Project:	Vilas Park Master Plan	Location:	Virtual Meeting - Zoom
MSA Project No.:	15885004	Date:	February 18, 2021
Meeting Purpose:	RRG/CPAG Final Master Plan Review	Time:	4:00 – 5:30 pm
Meeting Organizer:	Dan Williams/MSA

Vilas Park Master Plan

Community Information Meeting #4
February 4, 2021 6 pm
Final Master Plan

Final Plan

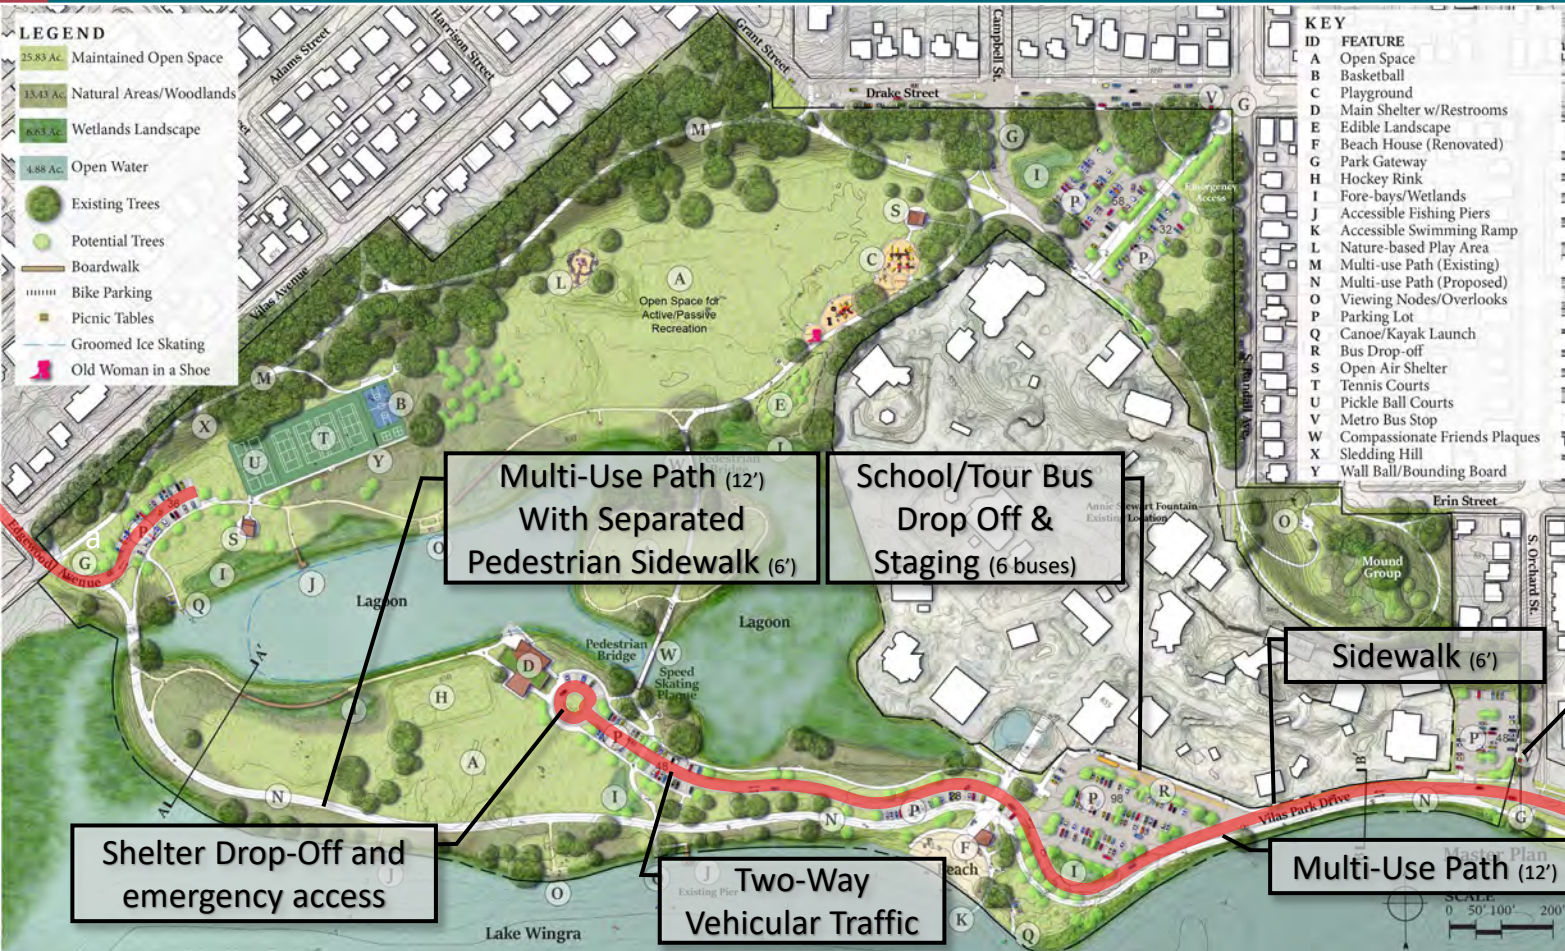
- I. Reduced parking capacity in North Lot to retain additional green space.
- II. Added nature-based play area east of Vilas Ave. on west side of meadow.

- III. Removed several of the proposed paths around the lagoon to reduce amount of impervious area.
- IV. Reduced parking capacity and moved open shelter closer to tennis courts. Flipped location of tennis courts with pickleball courts. Added 'Wall ball'/bounding board. Added callout for sledding hill west of parking lot.

- V. Reduced amount of space dedicated to "Natural Areas" west of lagoon, now shown as "Maintained Open Space".
- VI. Master plan recommends further study of lagoon management.

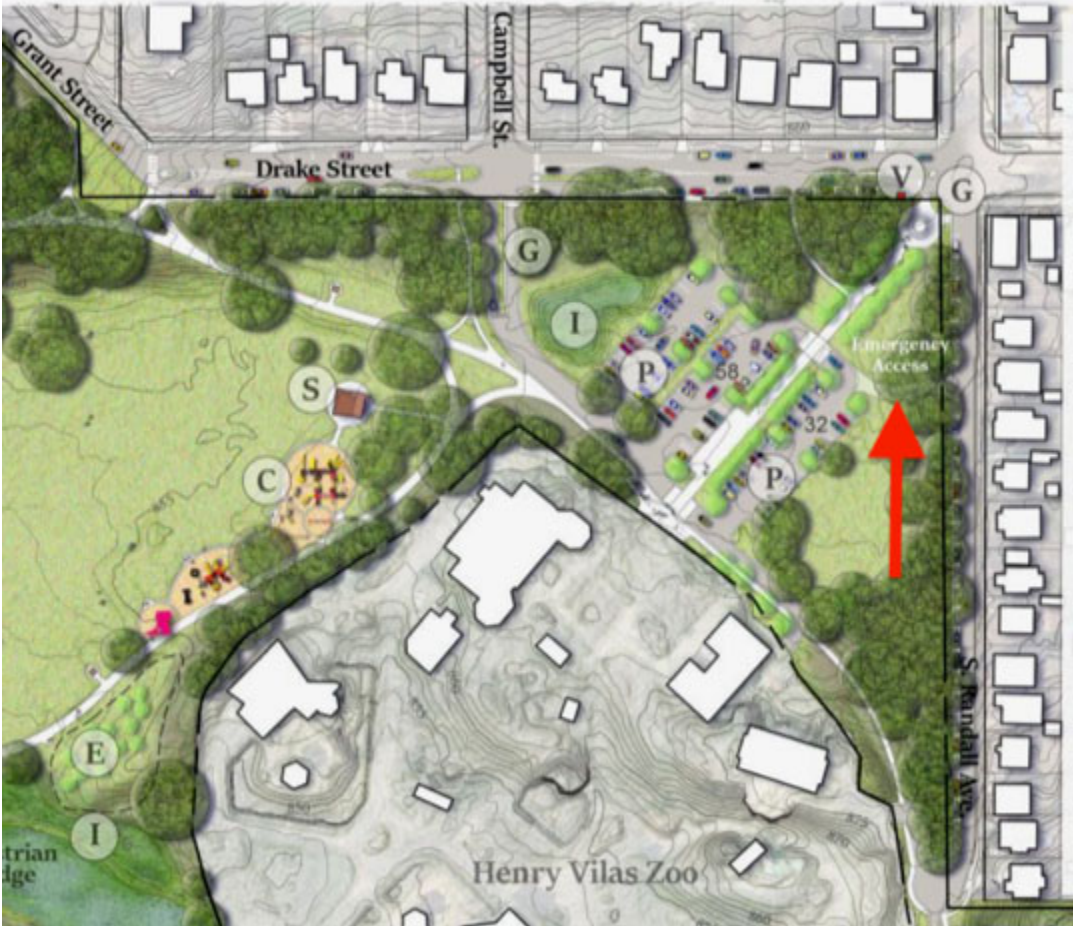
In attending the Vilas Park Master Plan community meetings, Parks has shared with us some renderings of Vilas Park changes. One such change has included moving the current entrance and exit to Drake & Campbell Streets. This would include both an entrance and exit for the public to Vilas Park and the parking lot. Parks has also included an "emergency access road" on the 500 block of S. Randall Avenue. This proposed emergency access point is the focus of my email. Parks has shared with us that City emergency services requested an emergency exit on our block, however, my neighbors and I have had some unanswered questions and concerns to the use and location of this emergency exit.

1. In what circumstances does City emergency services request special access points? Did City emergency services request this access point? What were the reasons?
2. Why would emergency services request our street? Since our street is quite narrow, we're having a hard time envisioning how emergency vehicles would be able use this road safely and efficiently. What would this access point look like? How wide would it have to be to accommodate emergency vehicles?
3. How will the emergency access point be accessible for emergency use only? How will it be closed off for public use?

For your reference, I've attached 2 screen shots below from the current master plan. The first is the whole map and the second is a zoom in of the emergency access road in question. I've place the red arrows to point out the Emergency Access road. This map is from the [Storymap](#) on the [Vilas Park Master Plan website](#).
